**From:** Manoj Nathoo (AT)  
**Sent:** Wednesday, 30 April 2025 9:39 am  
**To:** Siobhan O'Donovan (AT)  
**Subject:** FW: Karangahape Designs combined April 2025 SP mark up.pptx

**From:** Mitra Prasad (AT) <Mitra.Prasad@at.govt.nz>  
**Sent:** Thursday, 24 April 2025 12:00 pm  
**To:** Putri Kusumawardhani (AT) <Putri.Kusumawardhani@at.govt.nz>; Suresh Patel (AT) <Suresh.Patel@at.govt.nz>; Sophia Wang (AT) <Sophia.Wang@at.govt.nz>; Andy Irwin (AT) <Andy.Irwin@at.govt.nz>; Irene Tse (AT) <Irene.Tse@at.govt.nz>  
**Cc:** Manoj Nathoo (AT) <Manoj.Nathoo@at.govt.nz>  
**Subject:** RE: Karangahape Designs combined April 2025 SP mark up.pptx

**Subject:** Karangahape Designs combined April 2025 SP mark up.pptx

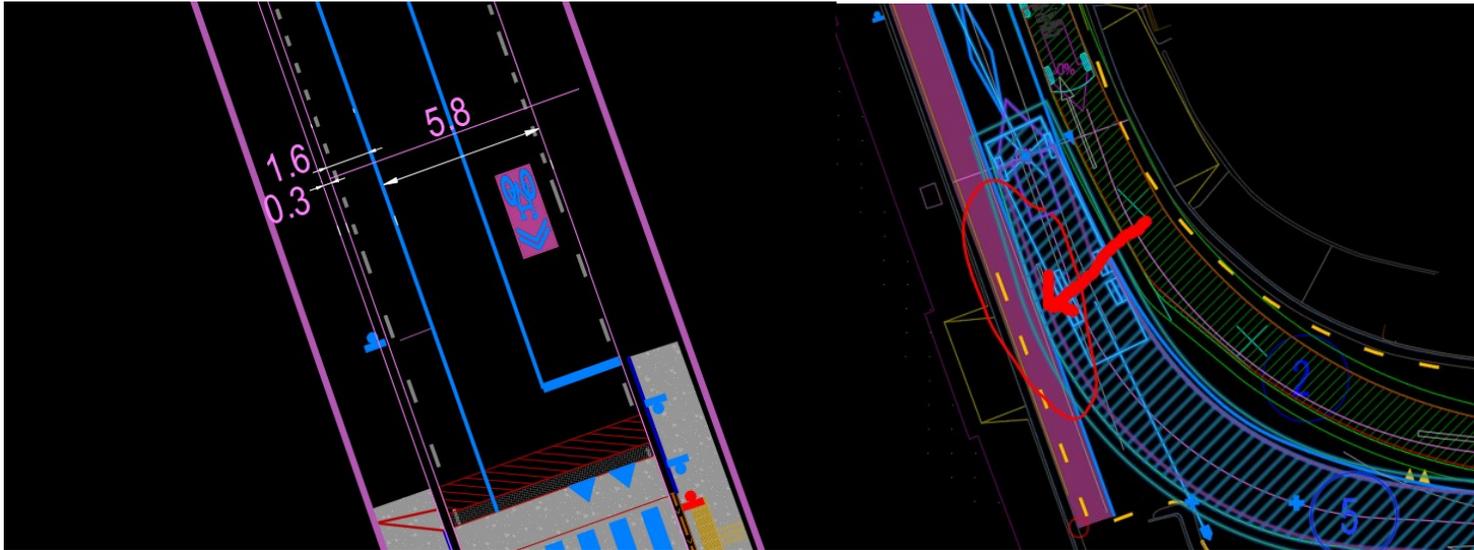
Wellington has been exploring the implementation of an uphill one-way cycleway and downhill sharrow due to their narrow traffic lanes and road gradients. Below is an image rendering from WCC's public consultation.

East St is designed as a low-speed environment, and with this type of road intervention (temporary) - a white line marking can be considered. There is a merit in providing an uphill dedicated cycleway, but the operational interface between uphill people on bike, northbound rubbish trucks, and southbound general vehicle - is something that need to be carefully considered. [@Andy Irwin \(AT\)](#) from Geometric should provide his insight for the (narrow) traffic lane width and tracking – since the narrow traffic lanes might trigger a Departure.

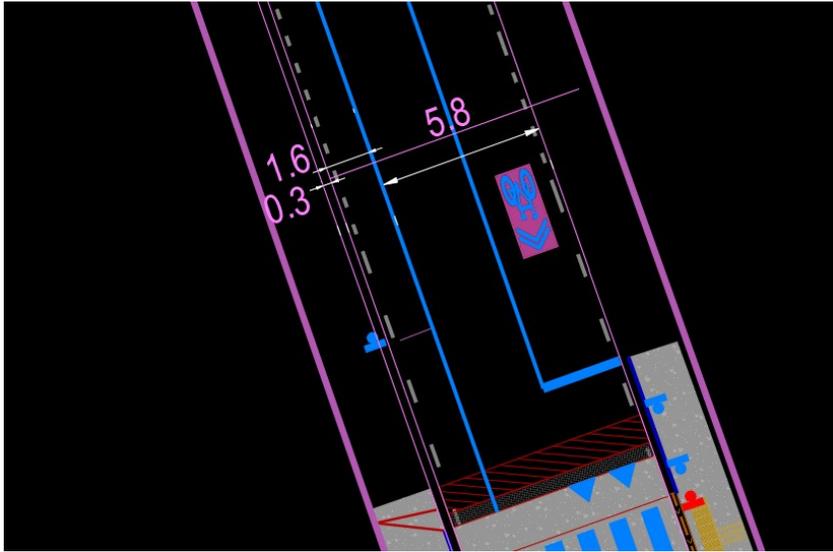
The cross-section at the most constrained section of East St with the unidirectional cycleway is defined by these widths:

<0.3m channel> <1.6m cycleway (min. as per practice note 04)> <2.9m NB lane> <2.9m SB lane> <0.3m channel>

The 2.9m lane widths are below the typical 3m minimum, but still above the 2.7m min. for local roads which East St is classified as. This is for the section of East St to the north of the proposed raised table crossing. Lane widths south of the crossing get as wide as 3.1m for both directions.

**Tracking at bottom of East St**

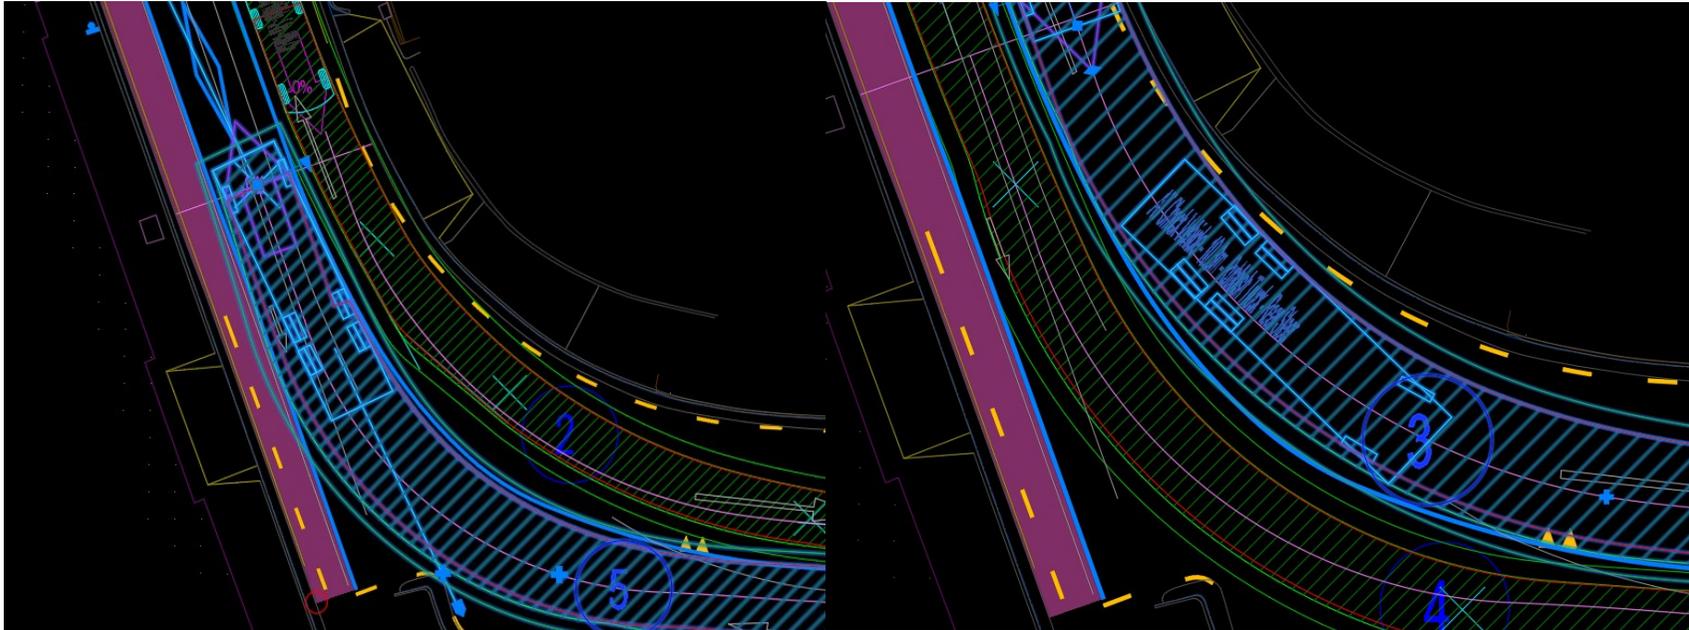
Tracking checks were completed using a 10.3m Rubbish truck and 95<sup>th</sup> vehicle going in opposite directions. Vehicle body wise, there are no clashes but the 0.5m clearances are overlapping in areas where the lanes narrow up. The 0.5m clearance for the rubbish truck tracking northbound also encroaches into the cycleway as seen in the snips below.
